**IN THE DRAWING:**

FIG. 4A

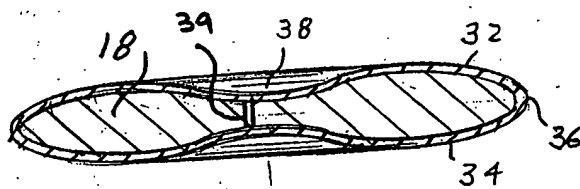
We have amended the drawings by adding Fig. 4A which shows an interior structural element 39 extending across the disk from one face thereof to the other in the interior of the disk in order to restrict the spacing of the faces of the disk at the location of the column; this is clearly described in detail at page 8, lines 6-24, and thus no new matter is being added.
